Application for Variation of an Environmental Permit

**Agreement No. CE 6/2015 (EP)
West New Territories (WENT)
Landfill Extension – Design and
Construction**

Supporting Document for Variation
of Environmental Permit

Drawing title
**PHASING OF LANDFILL CELLS
 IN ORIGINAL SCHEME**

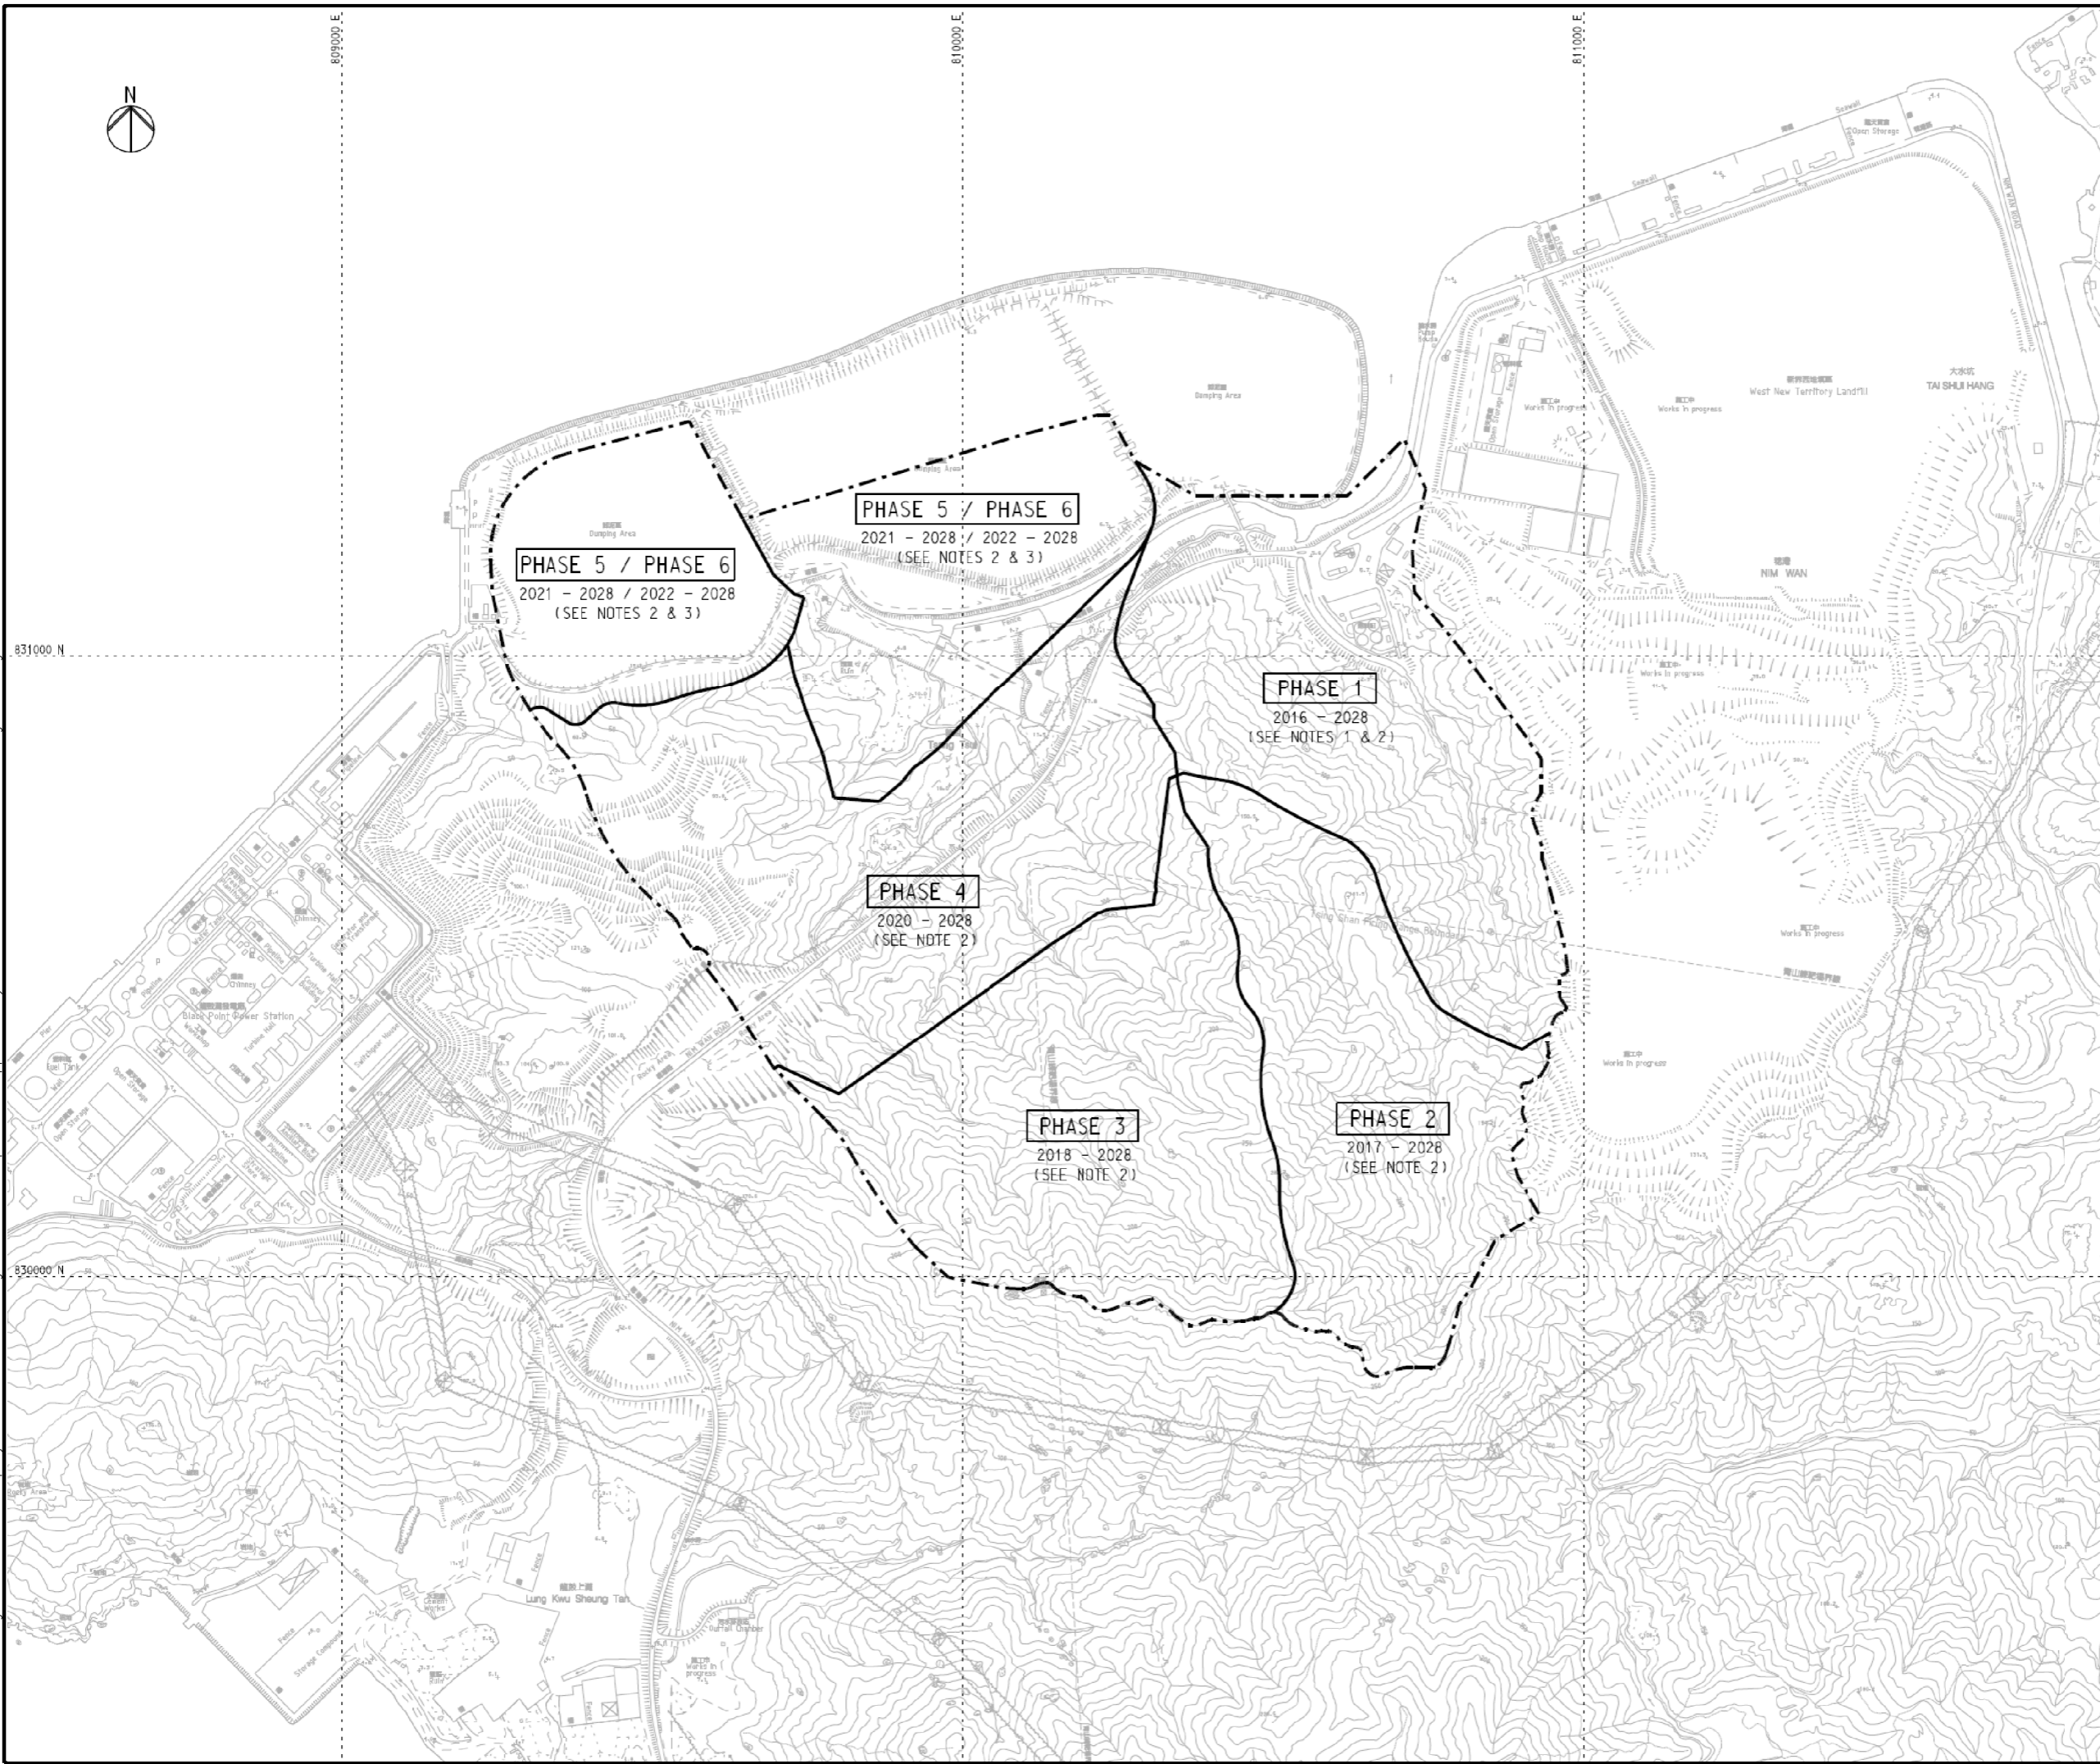
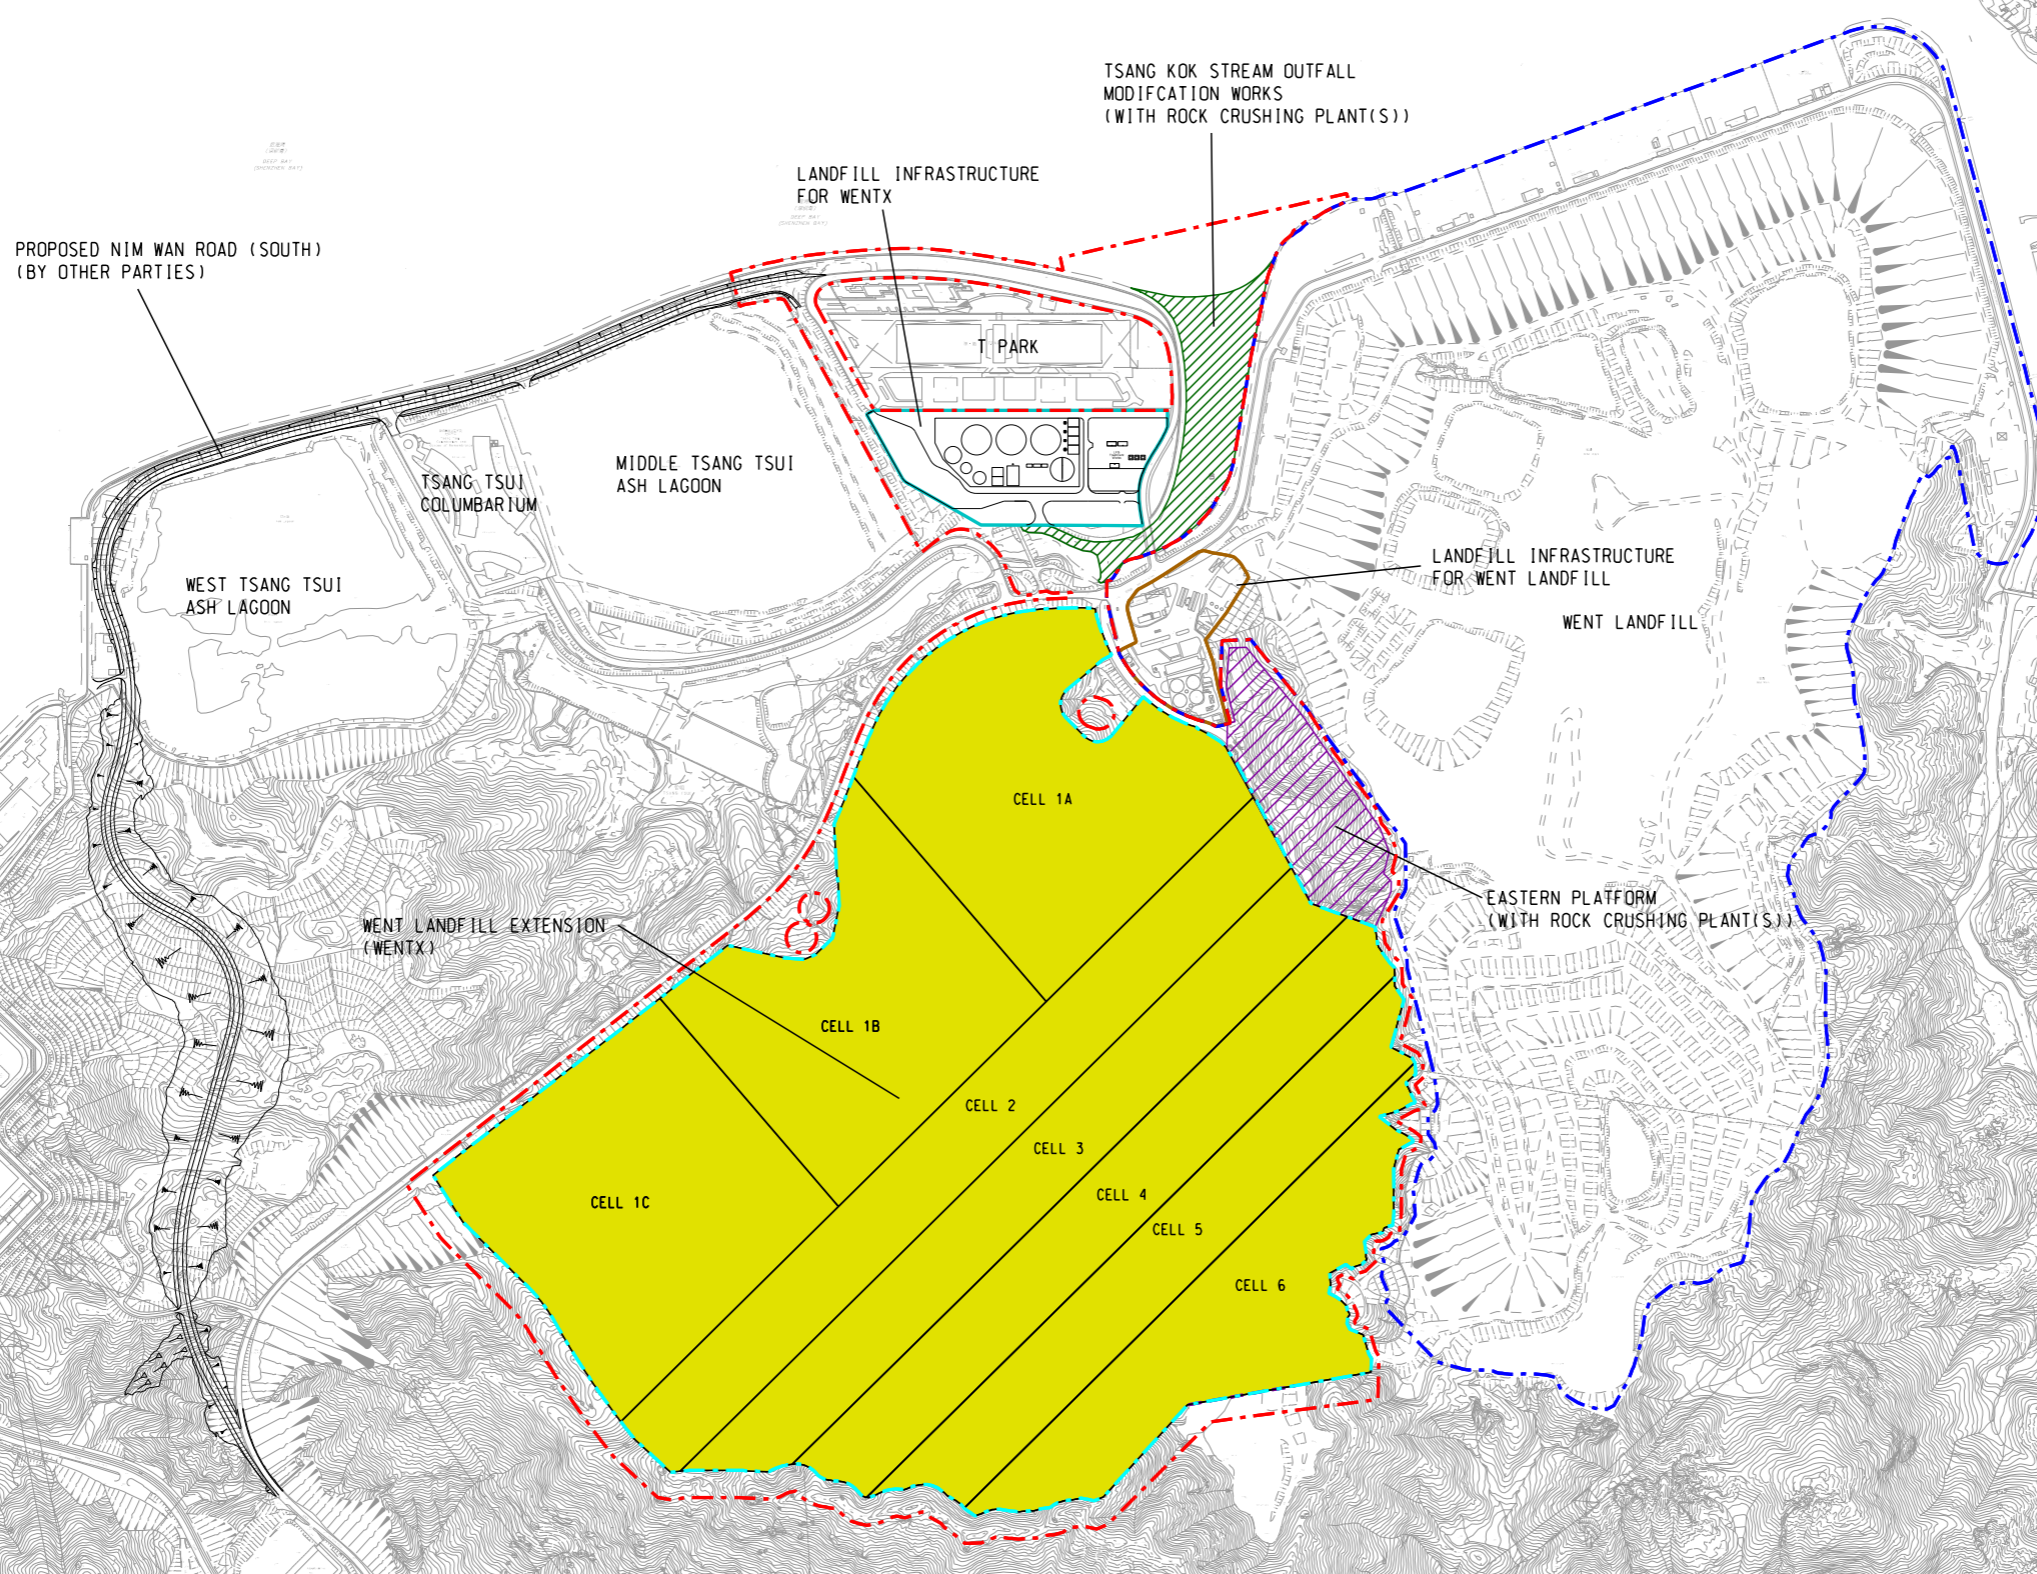
2.2.4 In the Original Scheme, the WENTX would be developed in phases, generally from the east to the west of the site in a clockwise direction, as shown in **Figure 2.1**. In the Enhanced Scheme, the WENTX would also be developed in phases, but generally from north near the Nim Wan Road to the south, as shown in the tentative outline phasing programme in **Figure 2.2**. In view of the design-build-operate nature of the WENTX project, the WENTX contractor will, upon contract award, prepare its own landfill development phasing plan to suit the actual site development programme, plants and resources availability, method of works, etc. The outline landfill phasing programme is only indicative and for reference use.

Drawing title
**LOCATIONS OF PROPOSED
 AIR QUALITY MONITORING
 STATIONS**

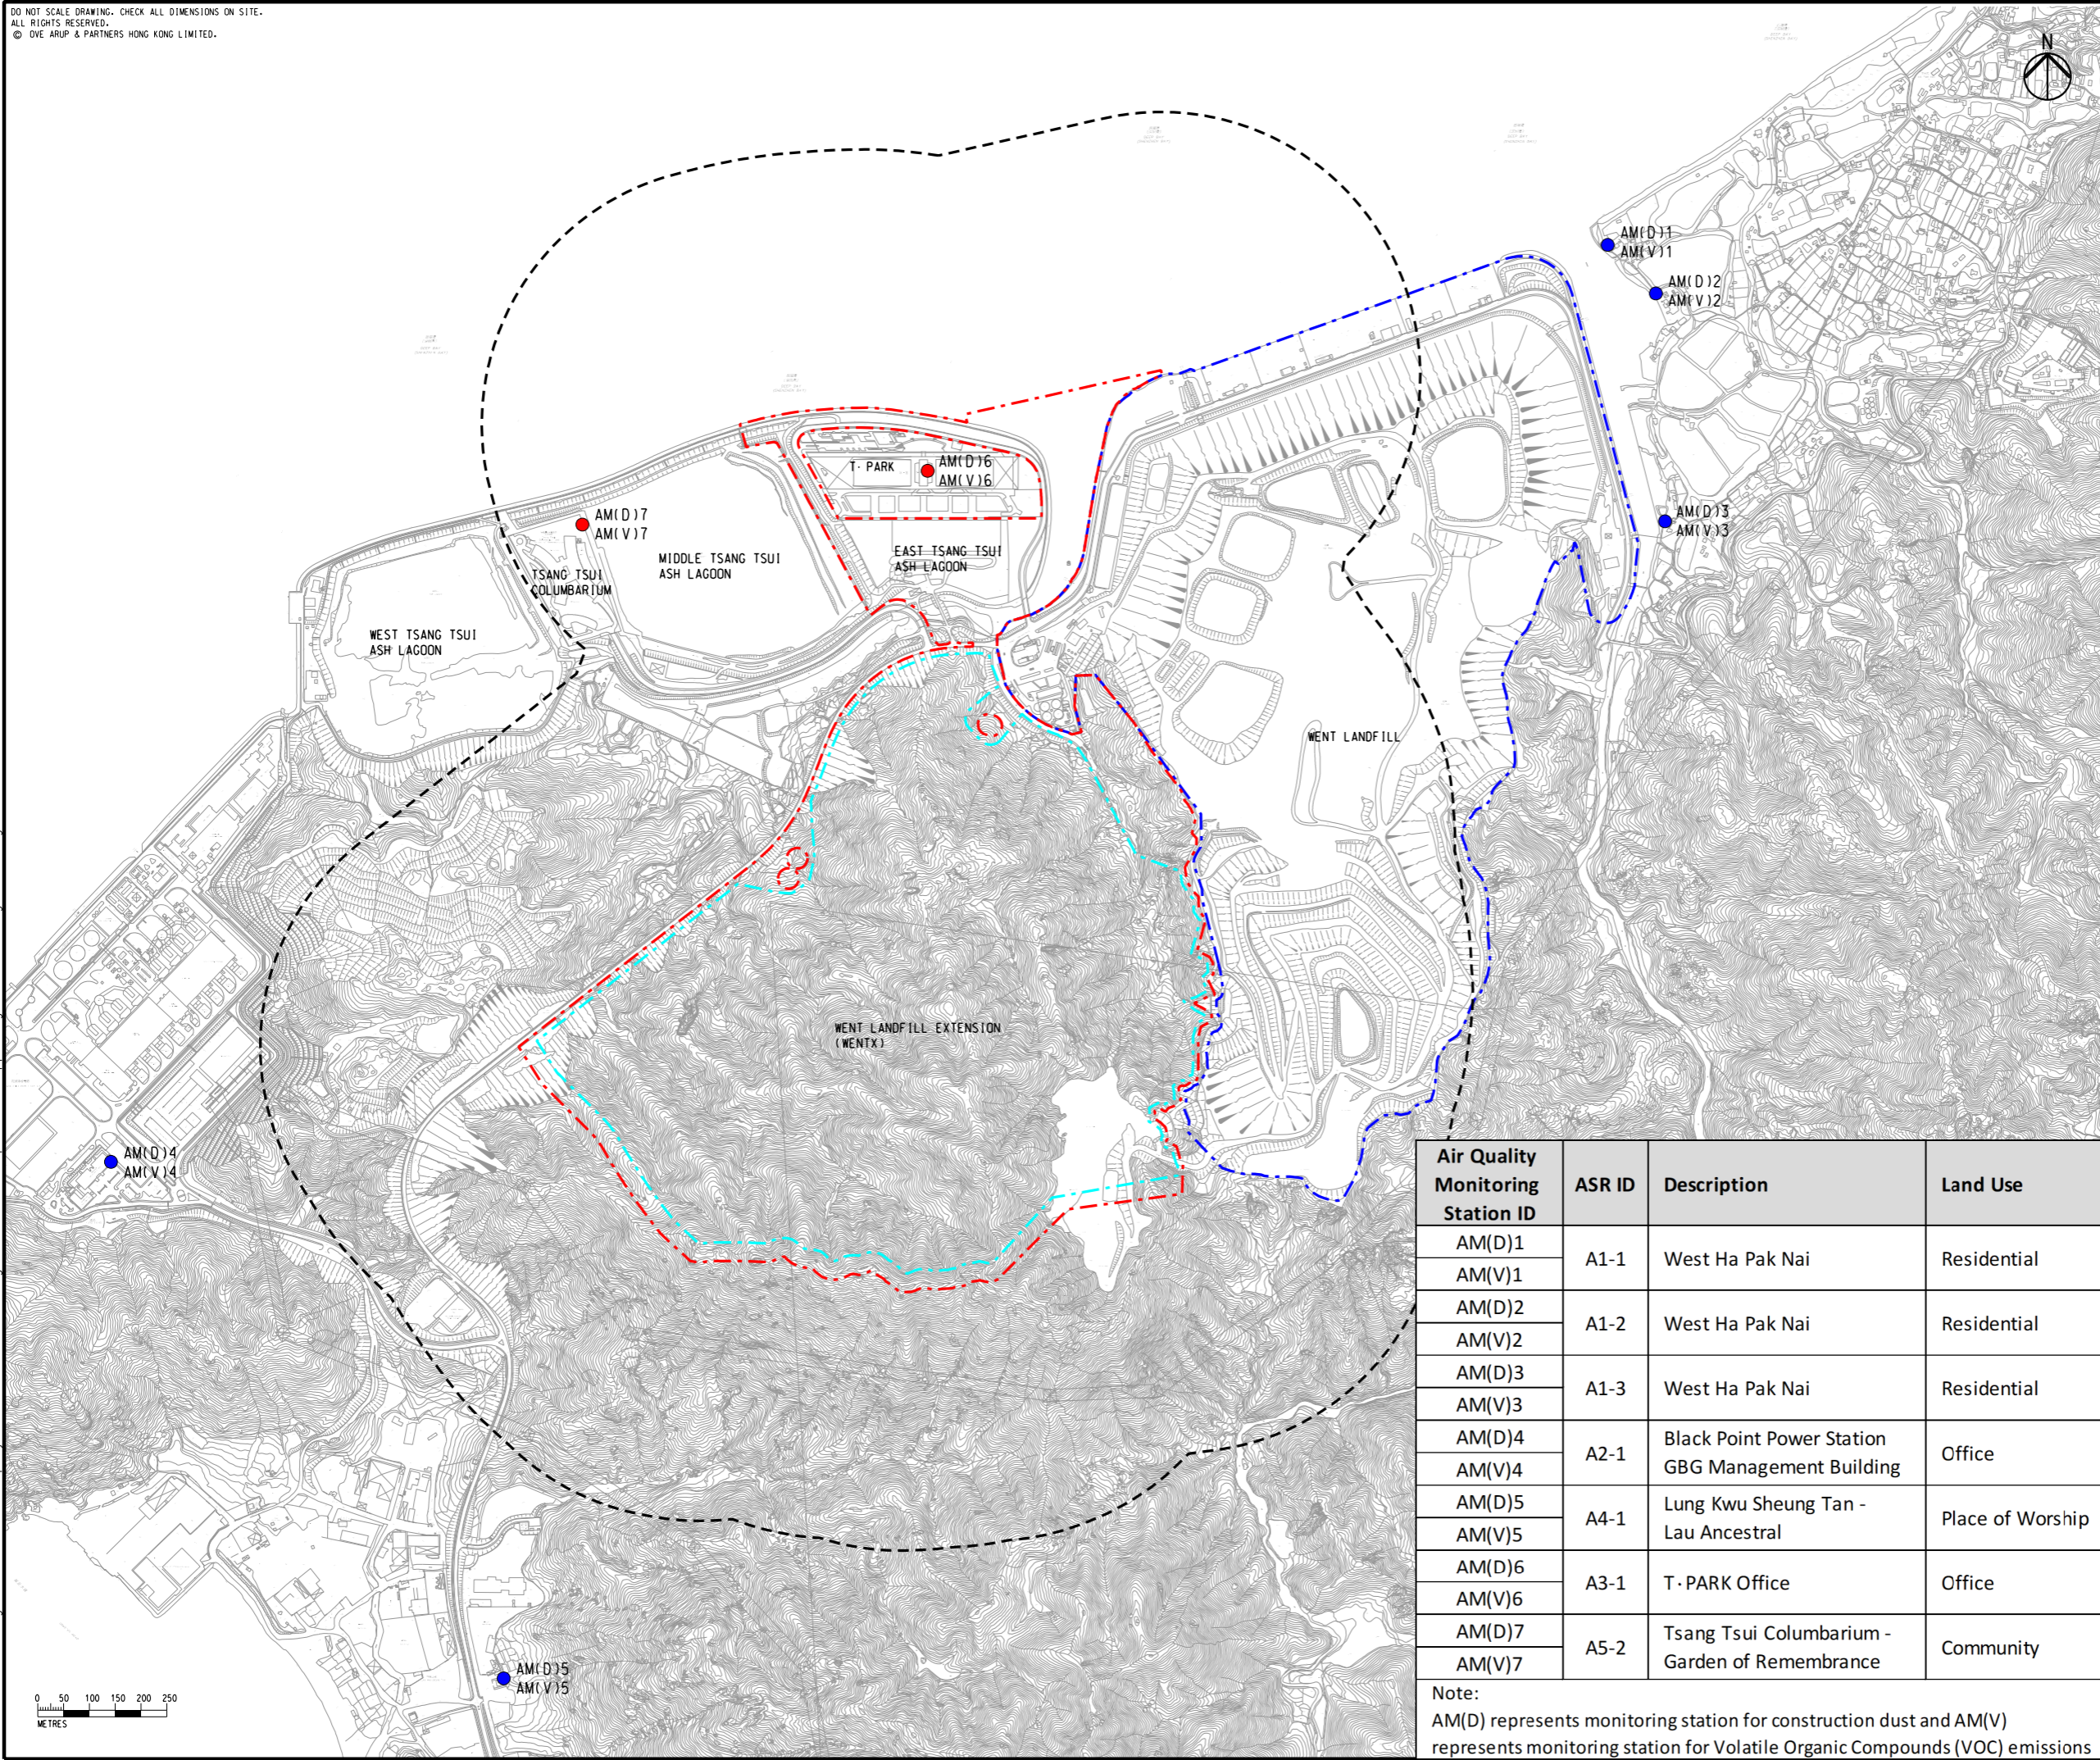
3.1.9 The EM&A programme as specified in the EM&A Manual shall be implemented to detect any deteriorating air quality and rectify the situation in a timely manner. No change on the recommended air quality monitoring locations is proposed. However, additional monitoring stations at T • PARK office and Tsang Tsui Columbarium are recommended (**Table 3.3** and **Figure 3.2**).

Station ID ^[1]	ASR ID	Description	Land Use	Description of Updates
AM(D)6 AM(V)6	A3-1	T • PARK Office	Office	New identified ASRs which are within 500 m of the Project Boundary and hence added. A5-2 is proposed as it is located closer to the Project boundary compared to A5-1.
AM(D)7 AM(V)7	A5-2	Tsang Tsui Columbarium - Garden of Remembrance	Community
